X3T10/94-188R0

To: Membership of X3T10
 From: Ralph O. Weber - Digital Equipment Corporation
 Date: September 15, 1994
 Subject: Proposed INQUIRY command enhancements (a.k.a TEST SUPPORT)

Table 18 - INQUIRY command

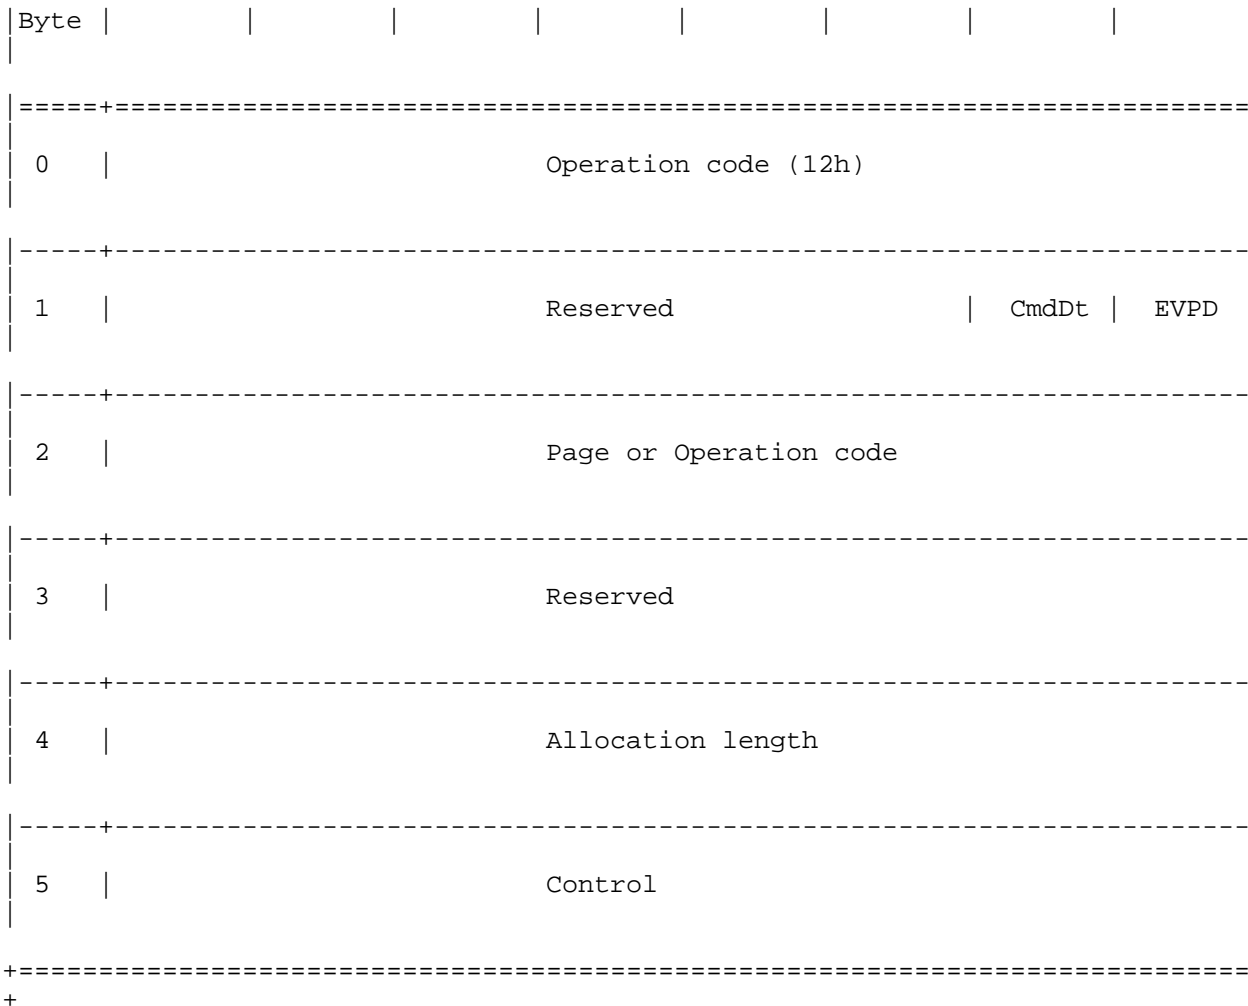
Modify clause 7.5 to read (changes are marked with change bars):

An enable vital product data (EVPD) bit of one specifies that the device server shall return the optional vital product data specified by the page code field. If the target does not support vital product data and this bit is set to one, the device server shall return CHECK CONDITION status with the sense key set to ILLEGAL REQUEST and an additional sense code of INVALID FIELD IN CDB.

A command support data (CmdDt) bit of one specifies that the device server shall return the optional command support data specified by the operation code field. If the device server does not support returning command data and this bit is set to one, the device server shall return CHECK CONDITION status with the sense key set to ILLEGAL REQUEST and an additional sense code of INVALID FIELD IN CDB. Details of the command support data can be found in clause 7.5.4.

If both the EVPD and CmdDt bits are zero, the device server shall return the standard INQUIRY data (see clause 7.5.1). If the page or operation code field is not zero when both EVPD and CmdDt are zero, the device server shall return CHECK CONDITION status with the sense key set to ILLEGAL REQUEST and an additional sense code of INVALID FIELD IN CDB. If both the EVPD and CmdDt bits are one, the device server shall return CHECK CONDITION status with the sense key set to ILLEGAL REQUEST and an additional sense code of INVALID FIELD IN CDB.

When the EVPD bit is one, the page or operation code field specifies which page of vital product data information the device server shall

return (see 8.4). When the CmdDt bit is one, the page or operation code field specifies the SCSI operation code for which device server shall return command support data (see 7.5.4).
